We would like to thank this referee for his/her interesting comments and suggestion that will contribute for improving our paper and clarify specific points. Hereby we present the authors reply (AC) to the referee's comments (RC).

Geometry and symbols of a slug test (Dax, 1987)

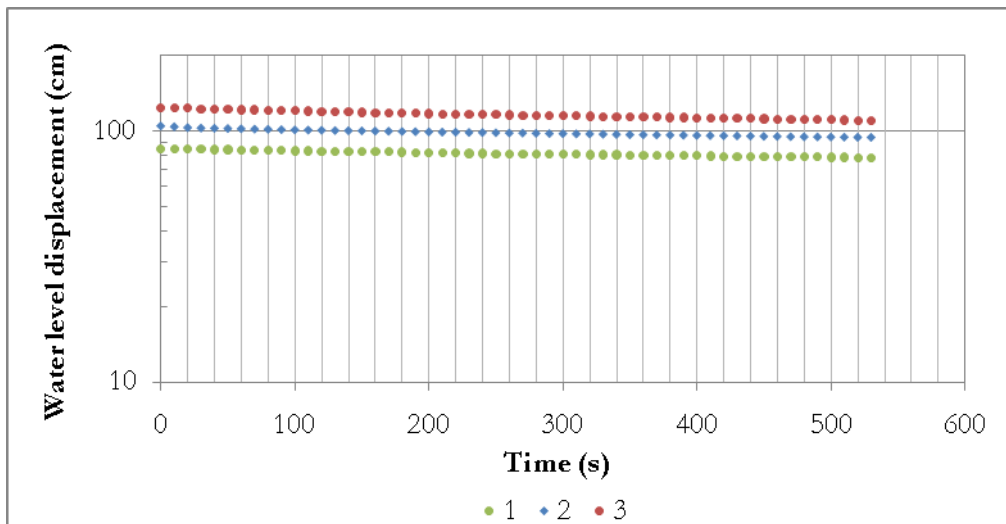
RC: The  $r_c$  and  $L$  are geo-metrical factors, and the  $D(\alpha)$  is a variable also containing time  $t$ . The  $D(\alpha)$  includes a term for the storativity  $S$  of the soil which represents the capacity for elastic storage depending on the compressibility of the material (Hinsby, 1992). The  $S$  can be obtained using the Cooper method when the unconfined aquifer is showing a delayed yield response. ! it should be shown how  $r_c$  and  $L$  are obtained,  $D(\alpha)$  should be explained (equation), explain more detailed how  $S$  is obtained

AC:  $r_c$  is the inside radius of the piezometer standpipe and  $L$  is the length of the filter pack (see figure below).  $D(\alpha)$  (-) is tabulated by Dax (1987) and:

In the article, it will be explained a bit more as follows: "The Dax expression can be described as follows:

$$K_h = \frac{r_c^2 \cdot \ln(H_o / H_t)}{L \cdot t \cdot D(\alpha)}, \quad \alpha = S \cdot \frac{r_w^2}{r_c^2} \cdot \frac{L}{B} \quad (-)$$

where  $K_h$  (m/d) is the horizontal conductivity,  $t$  (d) is time, and  $H_t$  (m) and  $H_o$  (m) are groundwater heads, following the injection of water, at time  $t$  and at the start of the test. The  $r_c$  is the inside radius of the piezometer standpipe,  $L$  is the length of the filter pack, and the  $D(\alpha)$  is a variable also containing time  $t$  (Dax, 1987). The  $\alpha$  includes a term for the storativity  $S$  of the soil which represents the capacity for elastic storage depending on the compressibility of the material (Hinsby, 1992). The parameter also incorporates the  $r_w$  (m) and  $B$ , also describing borehole geometry. Where the unconfined aquifer is showing a delayed yield response, the  $S$  can be obtained using the Cooper method (Cooper et al., 1967)

Figure X Discrepancies between the groundwater levels of the calibrated model and measured heads

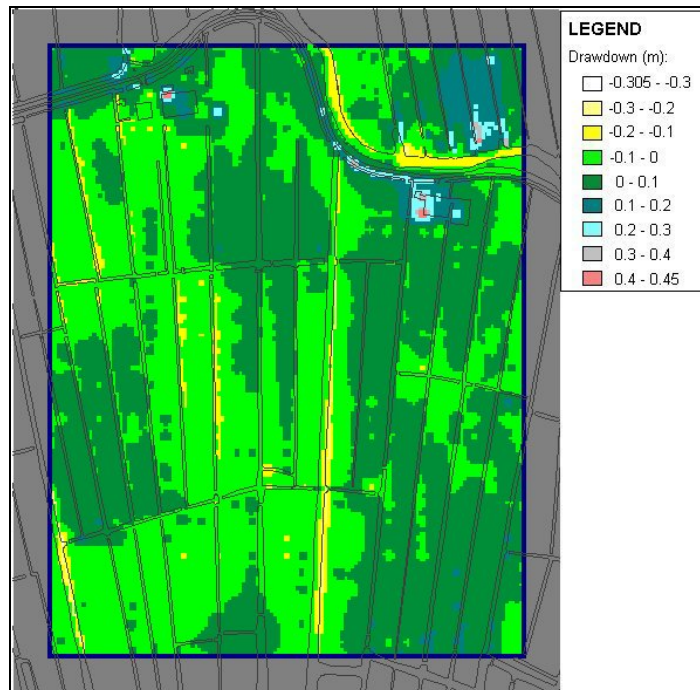
RC: Please provide a calibration plot (measured versus simulated heads)!

AC: *A plot of differences between observed heads and computed heads is provided below. We did not include it in the article since we mention the mean value of the error in the text and we wanted to save space. In case you think it is better to include it in the article we can do this.*
